PIC16C65

PIC16C65 Rev. A Silicon Errata Sheet

The PIC16C65 (Rev. A) parts you have received conform functionally to the Device Data Sheet (DS30234D), except for the anomalies described below.

FIGURE 1: WRITES TO TIMER1 (EXTERNAL CLOCK / OSCILLATOR MODE)

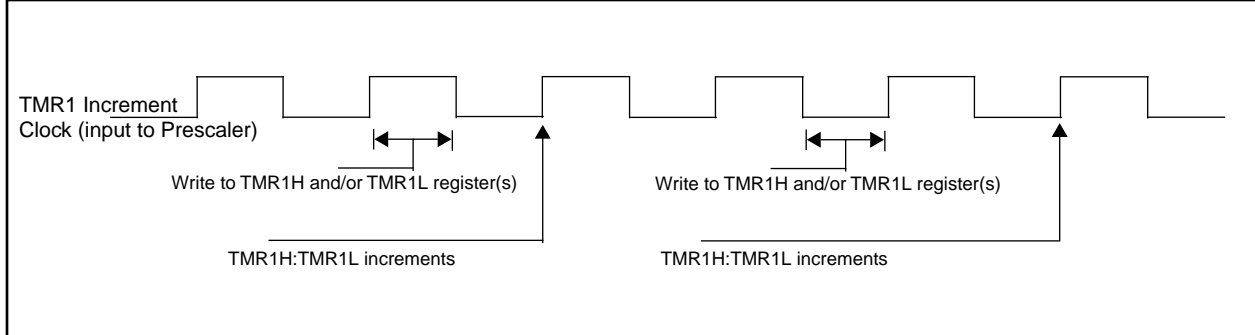
- a) The operation of Timer1 needs some clarification when the timer registers are written when the TMR1ON bit is set.

The internal clock signal that is the input to the TMR1 prescaler affects the incrementing of Timer1 (TMR1H:TMR1L registers and the Timer1 prescaler). When the Timer1 registers are NOT written, the Timer1 will increment on the rising edge of the TMR1 increment clock.

When the TMR1H and/or TMR1L registers are written while this clock is high, TMR1 will increment on the next rising edge of this clock.

When the TMR1H and/or TMR1L registers are written while this clock is low, TMR1 will not increment on the next rising edge of this clock, but must first have a falling clock and then the rising clock for TMR1 to increment.

Figure 1 shows the two cases of writes to the TMR1H and/or TMR1L registers. Due to the V_{IH} and V_{IL} thresholds on the oscillator/clock pins, external

Timer1 oscillator components, and external clock frequency, the Timer1 increment clock may not be of a 50% duty cycle.

The TMR1 increment clock is out of phase of the T1OSO/T1CKI pin by a small propagation delay.
